RIVER HEIGHTS CITY PLANNING COMMISSION AGENDA

RE: Historic Sinclair Station – Preliminary Plan Review

Design Review and Approval Checklist for Sinclair Station

River Heights Historic
 Sinclair Station
 594 South 400 East
 River Heights, Utah

ARCHITECTURAL SITE PLAN
 SCALE: 1/8" = 1'-0" (1/4" = 1'-0")
 SCALE: 1/4" = 1'-0" (1/8" = 1'-0")

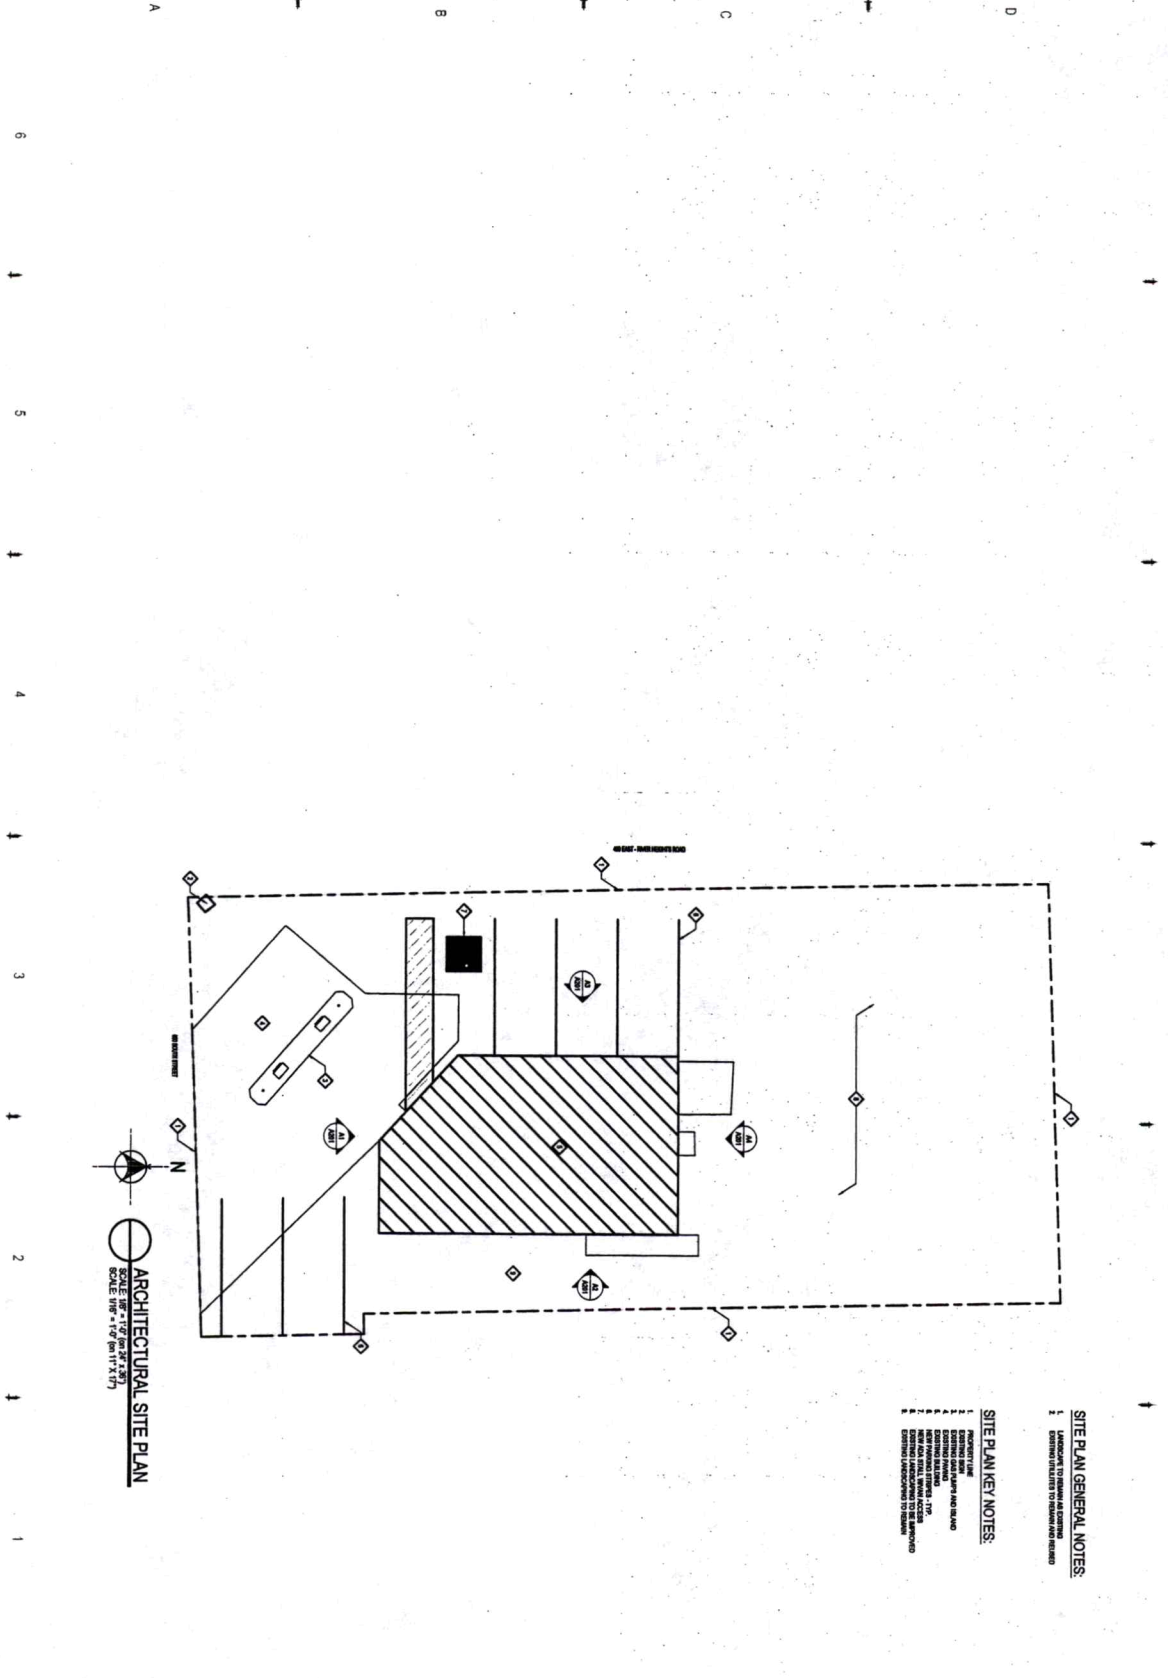
11. The developer may want to consider parking stops for the three stalls fronting the building on the west side to protect the building from vehicle impact.
12. The Schematic Site Plan (P1) does not match the Architectural Site Plan shown on sheet AS101. Please coordinate and update sheets as required, such as showing ADA parking on the schematic plan.
13. It has been stated that the original sign base is proposed to be used for a new sign at the corner of 400 East and 600 South streets. The proposed sign should be included in the approval process.

with Irrigation Details
 Grading & Drainage Plan
 Sheet Scale - 1" = 5'

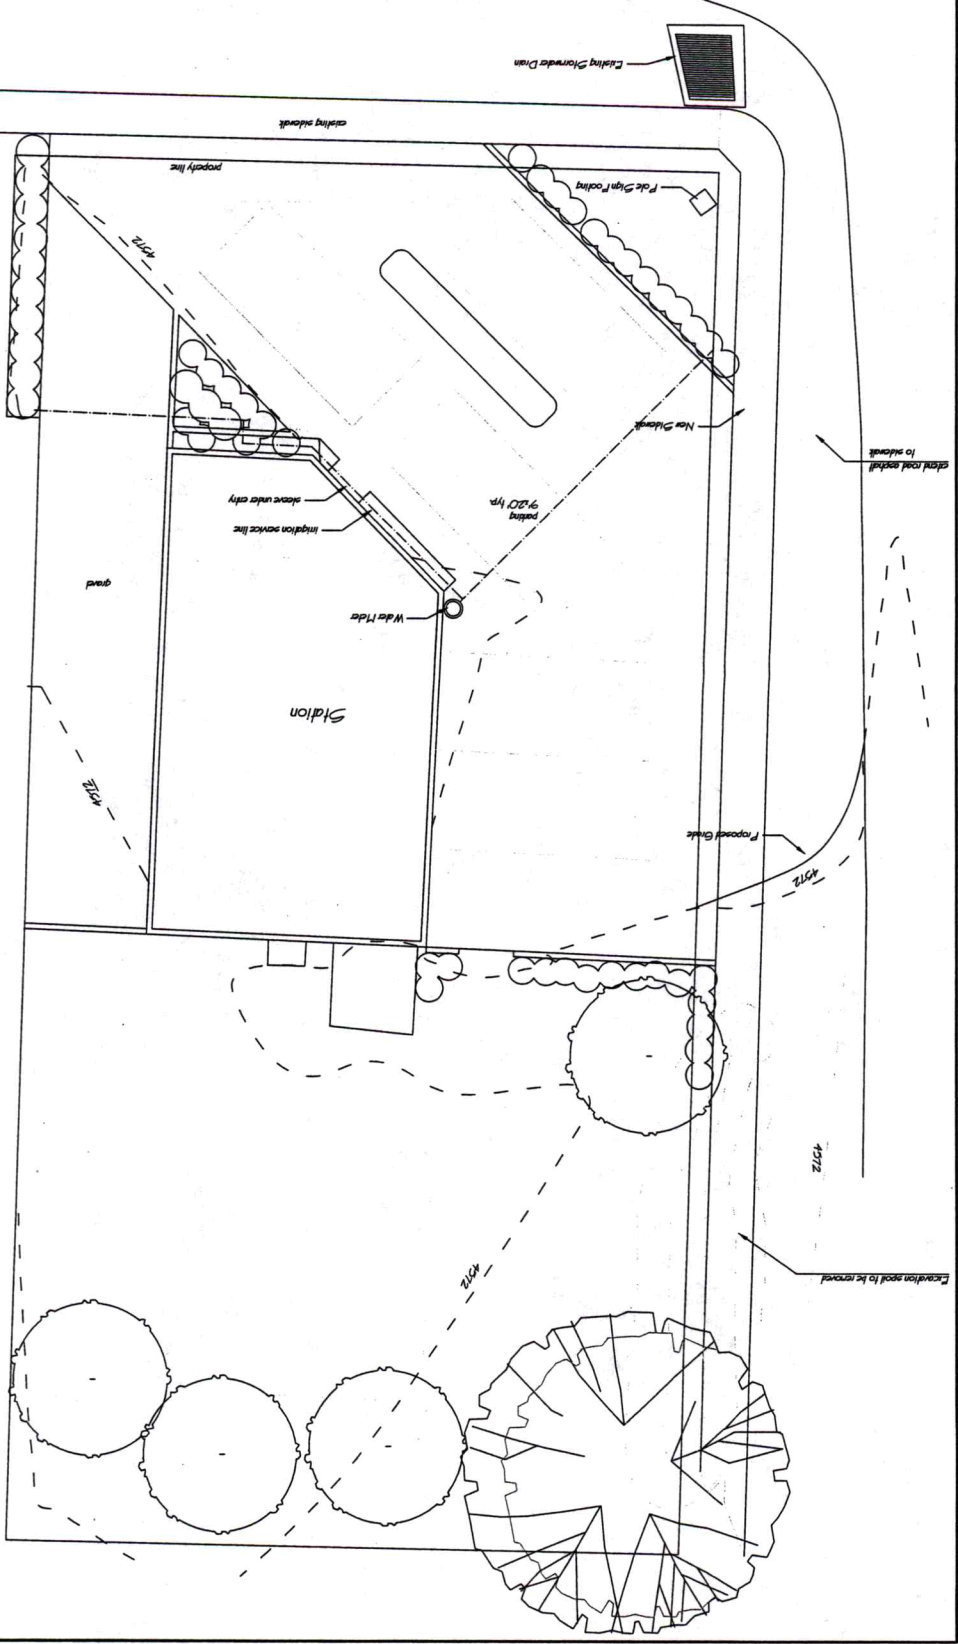
4. The grading and drainage plan shows a single contour on the site. However, the site topography appears such there is insufficient relief to illustrate slope with the single

contour. A visual observation of the site appears to indicate a slight slope down toward the north over the westerly portion of the site. Whereas new pavement along the western side of the station has been discussed as an improvement for this spring/summer a final grading plan to verify/establish adequate slope should be prepared in accordance with the Design Review and Approval Checklist. The Preliminary Plan should be revised to show, at a minimum, drainage slope arrows for the varying locations of the site.

5. The developer discussed paving the space between the road and the existing/proposed sidewalk on the south and west sides of the project, respectively. The site is lower than the roadway and paving this space will channel stormwater onto the site where hard surface paving will prevent infiltration. The grading plan should address how the storm water will be managed (see comment No. 2). It is assumed that the westerly part of the site will be configured to drain to the landscaped area north of the building, but it appears that the south side may not drain this way without additional grade changes or channelization methods. If additional channelization is required the preliminary plan should so indicate. Alternatively, the landscape area in the southwest corner could be investigated by the developer for addressing stormwater on the south portion of the site.

6. Notes on the grading plan indicate irrigation service lines to three specific landscape areas on the south part of the site. Notes also specify the irrigation system is to be a designed by the installer. A design by installer irrigation system is acceptable; however, the plans should indicate that a reduced pressure backflow preventer is to be provided.

7. The current water meter location is next to the southwest corner of the building. This is generally not where water meters are located and the City would prefer the meter to be located near the property line in accordance with City standards. Please coordinate with the Public Works Director to identify the preferred meter location and location of existing service line if traceable. Correcting the location of the water meter will impact irrigation service lines.

8. The existing "Stormwater Drain" at the southwest corner of the property is an irrigation diversion structure and does not, collect stormwater. Irrigation utility lines should be shown on the plans such that they are protected and preserved with improvements planned for the site.

Illustrative Planting Plan
 Sheet Scale - 1" = 5'

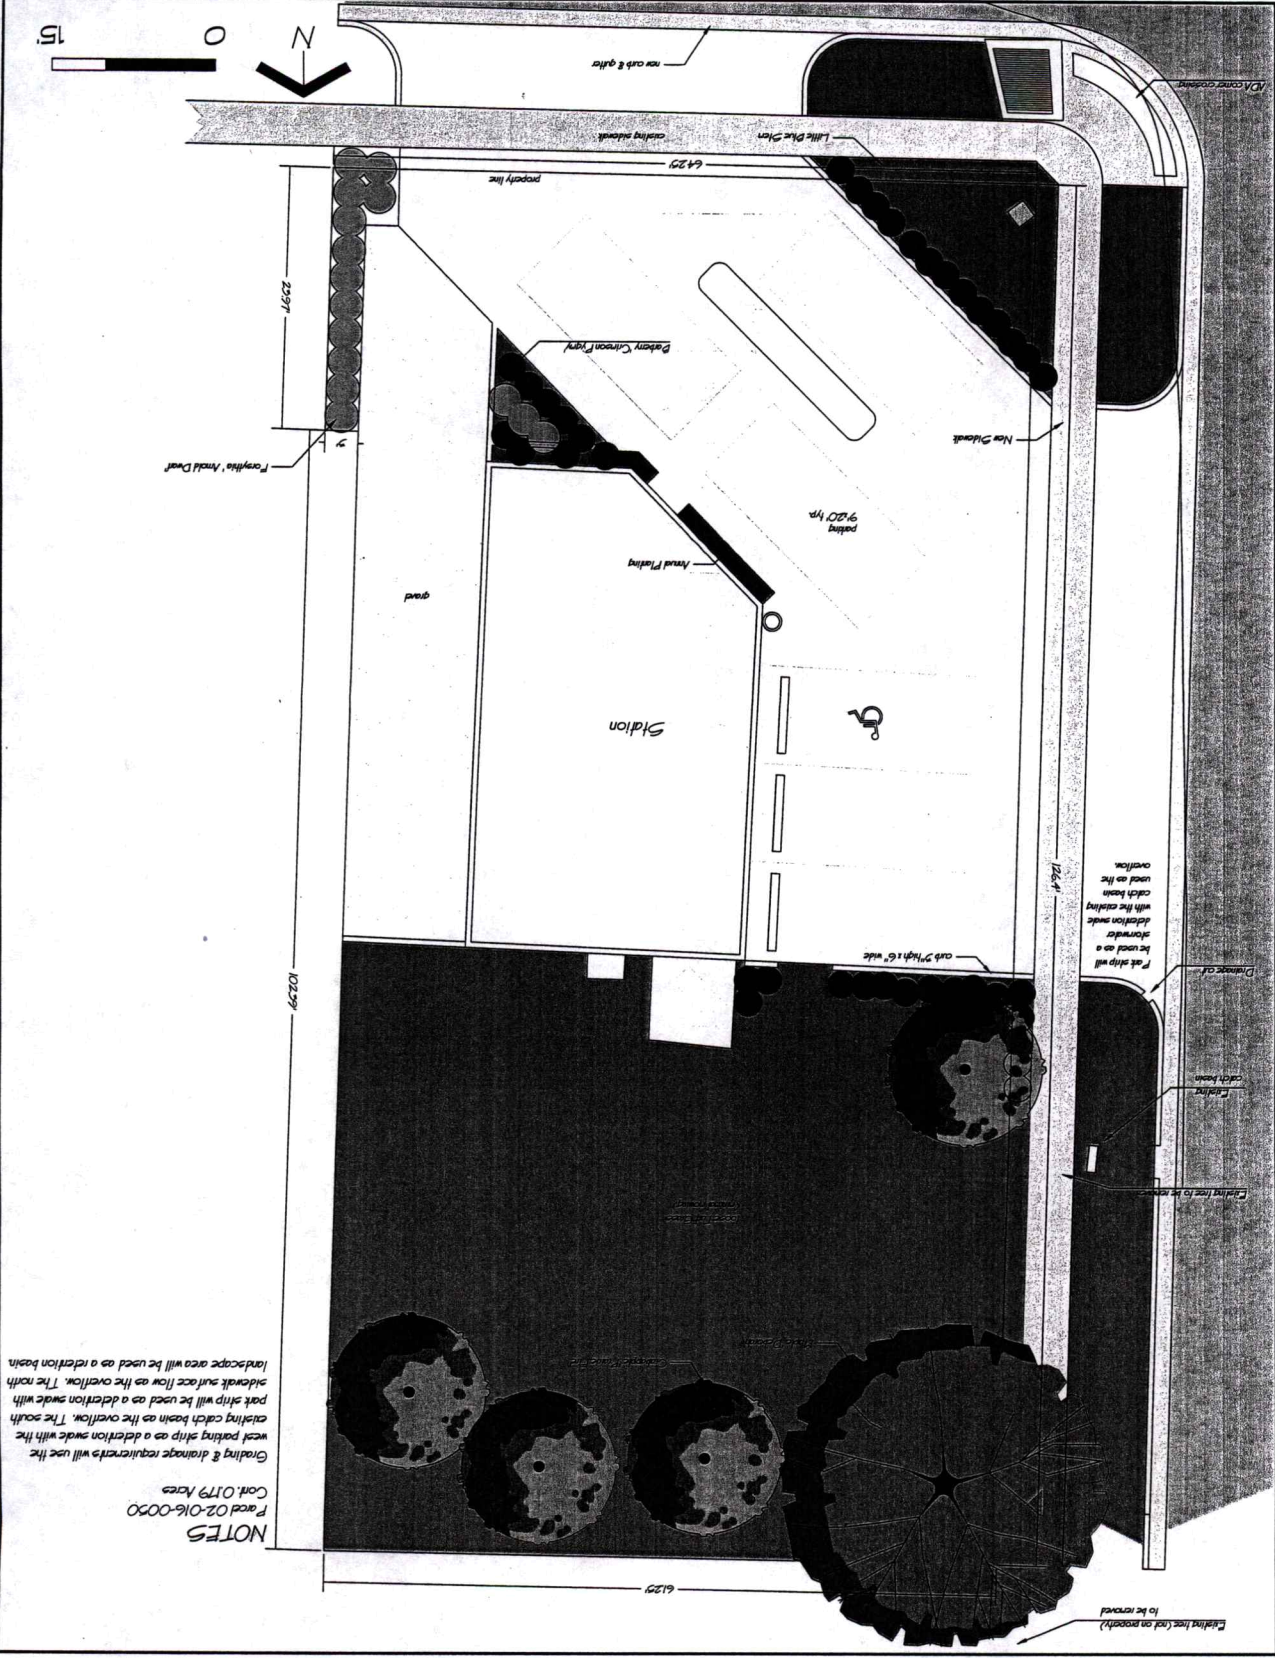
9. City Ordinance prohibits driveways within 6 feet of the property line. To comply with this requirement the easterly section of concrete extending from the pump island should be removed or otherwise show compliance with this requirement.
10. At present, the plan appears to indicate paving by hatched area to extend about 12 feet east of the property line along 600 South, and approximately 15 feet north of the end of the parking access on 400 East. It is suspected that the hatch is simply a generalized

indication. The preliminary plan should show the specific extent of pavement proposed from the existing road to the site at the street access points.

14. Ordinance 10-15-5 A.4. Specifies that a 3 foot wide planting area shall be placed around the perimeter of the building footprint except at entrances and utility locations. Whereas the project is attempting to restore the project to prior conditions it is expected that the landscaped perimeter would be waived on the southwest and west sides of the building. The Planning Commission should address how the east side of the structure is to be addressed. Currently the plans show a graveled way from the building to the east property line.

15. It has been discussed that the existing tree located due west of the northwest corner of the building will most likely be removed. If this is the case, the landscape plan should so indicate and the planting should be adjusted accordingly.

16. Performance landscape plan appears to accommodate the number of trees, shrubs, and landscaped area required by the ordinance.

- 38 2. The buffer strip on the east side be a combination of green and gravel with the
39 greenery next to the building.
40 3. Not require a landscaping buffer on the west side of the building.
41 4. Require an updated schematic site plan be provided to the council.
42 5. Require a security of performance bond for 150% of the cost of the exterior
43 improvements.
